Your ref.:  
CDM Ref 3048

Date:  
5 March 2010

## **Response to request for review “Cimentos do Mozambique – Matola Gas Company Fuel Switch Project” (3048)**

Figure 1: South African coal export monthly prices, February 1990 – December 2008. Source: Index Mundi<sup>1</sup>

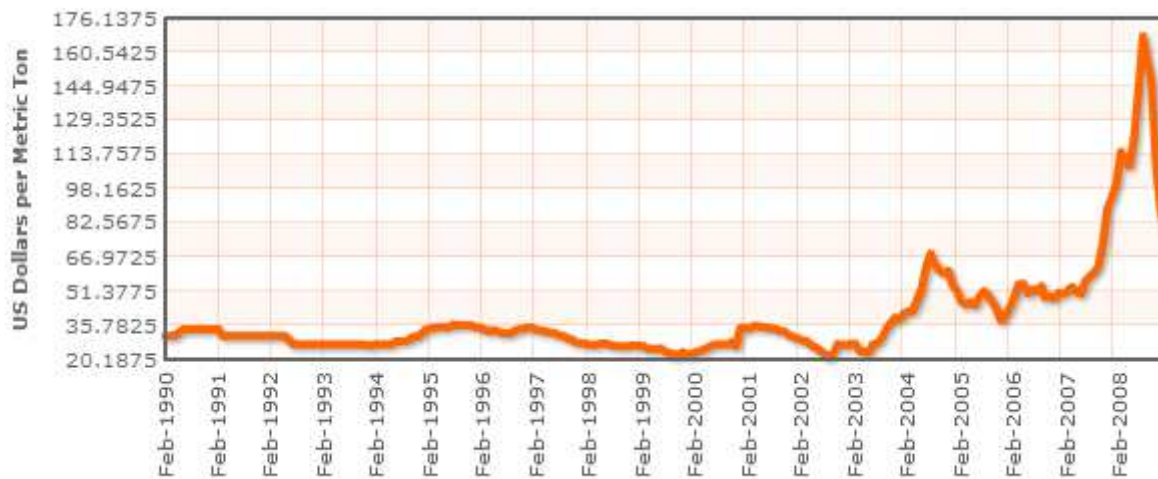
*The DOE needs to further explain how it has validated: (a) coal price escalation of 20% for the first five year and 3.6% for the rest of the years, and (b) the exclusion of saving from diesel usage in the NPV calculation.*

a) The project proponent has used an actual coal price for the financial analysis. This price is the price paid for coal delivered from their South African coal supplier in April 2007, a month before the decision to proceed with the project was made by the Board of Matola Gas Company on 30 May 2007. DNV has checked the coal purchase receipts from April 2007 from the Cimentos do Mozambique cement plant and crosschecked this with the coal supplier's delivery receipts from April 2007. DNV is hence of the opinion that the coal price used in the financial analysis was a realistic price at the time of the investment decision.

Cimentos do Mozambique saw a sharp increase in the coal prices in the period 2005 – 2007, which was evidenced by transcripts of the SAP accounting system, provided to DNV for verification. During this period, the coal prices increased in average 29% per year. Yearly increases of 29% can however not be expected over many years, so the project proponent selected a yearly price escalation of 20% for the first five years to reflect the recent volatility in the coal market, and a lower escalation of 3.6% per year after that to reflect a ‘normal’ price development over a longer time period. DNV was able to confirm 3.6% as the average yearly increase of the USA Price Producer Index over the ten years period 1998 – 2008.

The coal prices in South Africa had indeed been very volatile in the period from February 2004 until April 2007, as can be seen in Figure 1 below:

From the figure, it is evident that over time spans of several years, large variations in the coal prices would normally not be expected, however fluctuations over a few years can be large. DNV is of the opinion that it was reasonable of the project proponent to anticipate a larger-than-normal increase in the coal prices in the near end of the analysis based on the recent history, while for the long run a more moderate development would be reasonable based on historical data over a longer time period.
